SEWAGE DISPOSAL SYSTEM

MARYLAND STATE DEPARTMENT OF HEALTH

SUBDIVISION Dogwood ROAD 6802 Redberry Road LOT 2

SEWAGE DISPOSAL SYSTEM

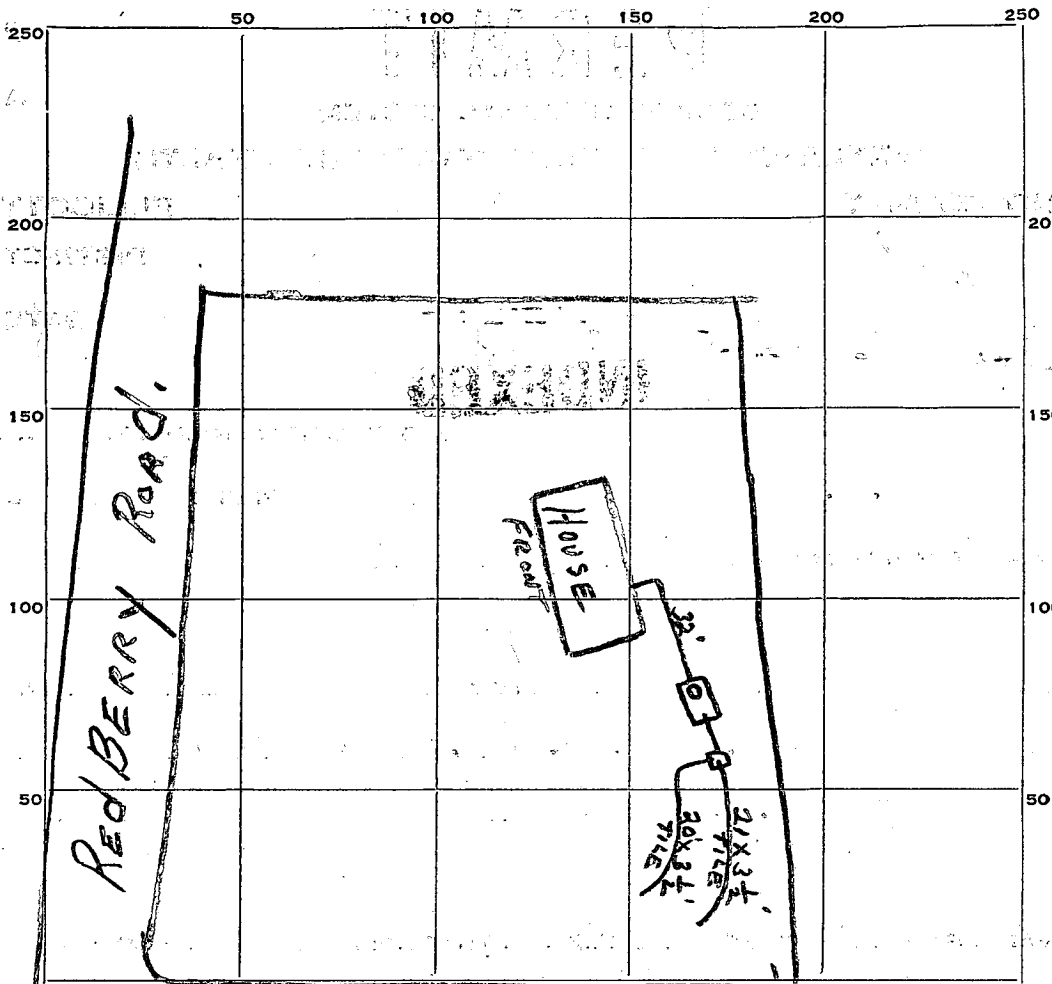
REMARKS 9-20-62 1. Need wide sweep sanitary lead on house sewer at joint 5 FT. out from house wall. 2. All of house sewer from house to S. tank not installed. 3. Need stand pipe on septic tank. JH.

80 at 62 Sewer connected from house to tank but there is a right angle bend and no stand pipe on curbside well

7 Sept 62 Retest Change to a Deep Tile Field with 350 sq ft bottom area installed at a depth of 5 ft to 6 ft and located between the House and Hall Shop Rd

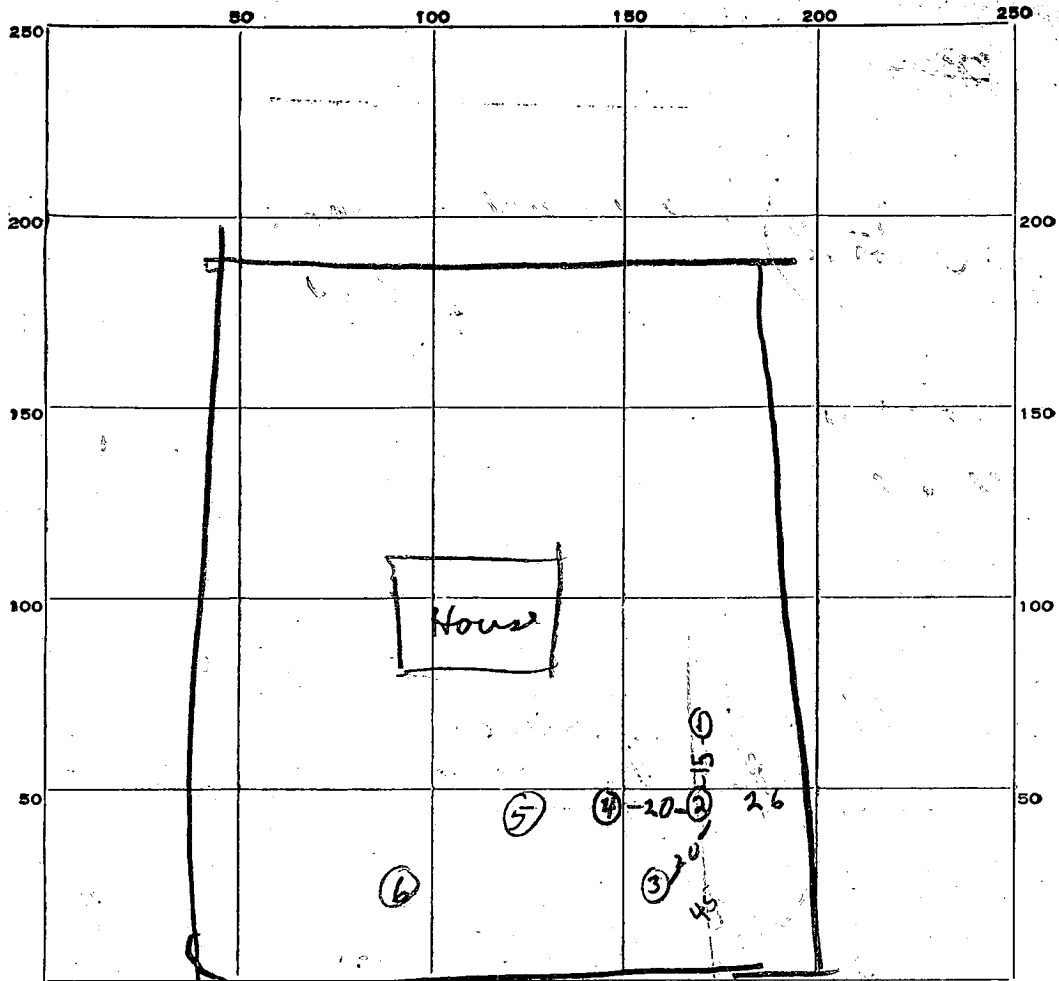
(after Braeburn, lot 18) 750 Gallon Tank  
change to Deep Drain Field - 3 to 6 ft deep  
with 350 sqft bottom area  
Place the field between the house and  
Hall Shop Road.
